*An analysis and an evaluation
of novelty, contributions and originality of the invention described in the
documents WO2011/078779, PCT/SE/051452, EP2010/0839900,
i.e. in Swedish patent SE 0901600-7.*

This paper provides an analysis and evaluation of novelty, originality, contributions and utilization of the invention described in the document WO2011/078779, PCT/SE/051452, EP2010/0839900 and USA patent application No. US 2012/0321531, i.e. in Swedish patent SE 0901600-7.

2.2.2. Reactor according WO2011/078779

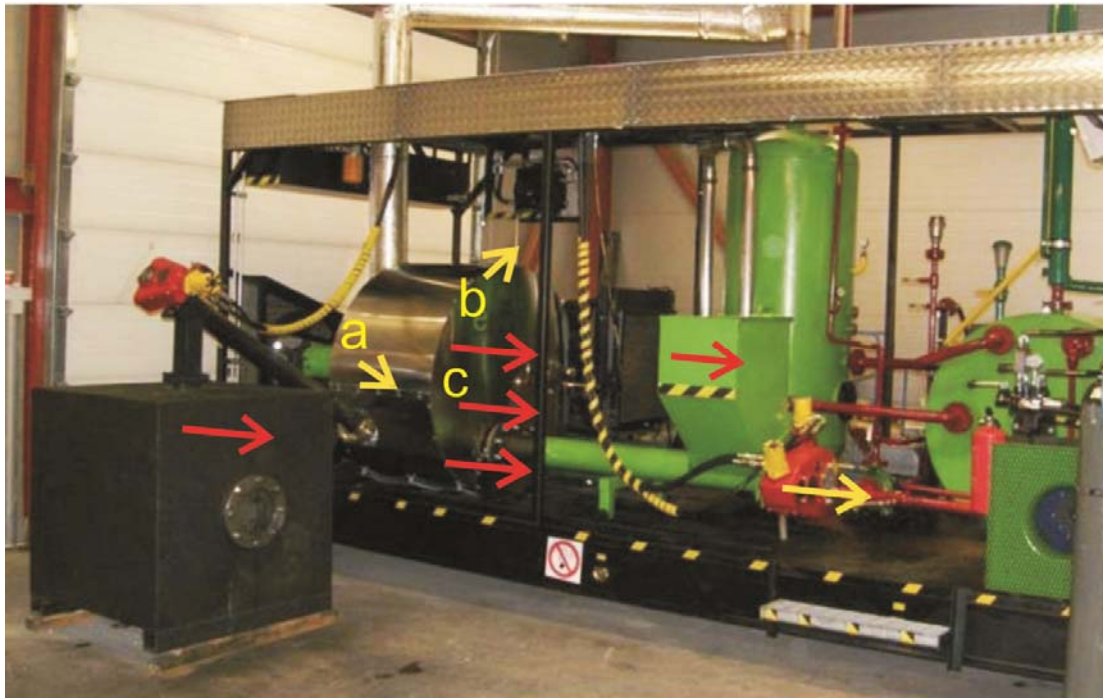
Technical solution described in the document WO2011/078779, on other hand, brings with 'de facto' more complicated access to the vanes/hammers as well as inner parts of the chamber and thus more extensive dismantling works than in the case of our reactors.

In order to replace vanes/hammers in the reactor described in the document WO2011/078779, it is necessary to dismantle the thermal insulation from the cylindrical part of reactor (at least) **6b** (Figures No. 2 and 3 from the application WO2011/078779) to enable access to the screws joining the circular flanges which connect the cylindrical part of the chamber of reactor **6a** and the part **6b**. The screws need to be disassembled and part **6a** needs to be released and moved aside from the fixed part of reactor **6b**.

Furthermore, it is necessary to move aside both feeding conveyors that are connected/mounted to the head wall of reactor **7** and also it's necessary to move aside the conveyor which withdraws so called process powder from the reactor and which is connected/mounted to the cylindrical side/part **6a** of the reactor's chamber. This conveyor is not mentioned in document WO2011/078779 and not displayed in the Figures, but without it the device cannot function. Moreover the picture of 600kW reactor which was published recently on official web site of patent application owner (www.cassandraoil.com) confirms that this emptying conveyor is also part of the whole arrangement (see pictures further).

All parts which are to be moved aside, means reactor parts **7** and **6a**, both feeding conveyors with drivers and inlet material hoppers, the emptying conveyor with driver and the process powder collector/hopper are installed on special carriage/carriages equipped with wheels moveable on rails.

When screws joining the circular flange which connects the fixed and removable cylindrical part of the reactor chamber are released and removed and simultaneously all moveable conveyors with accessories are pushed aside **then** the vanes and inners of reactor chamber are accessible.

The installation of the new vanes/hammers in the case of bigger devices would be quite difficult. Removing of insulation, dismantle of greater number of bolt/screws from the circular flanges of reactor chamber joining fixed and removable parts of chamber and manipulation with greater amount of mass/steel is needed. The dismantling works can take an hour or some hours, while back installation will take even longer.
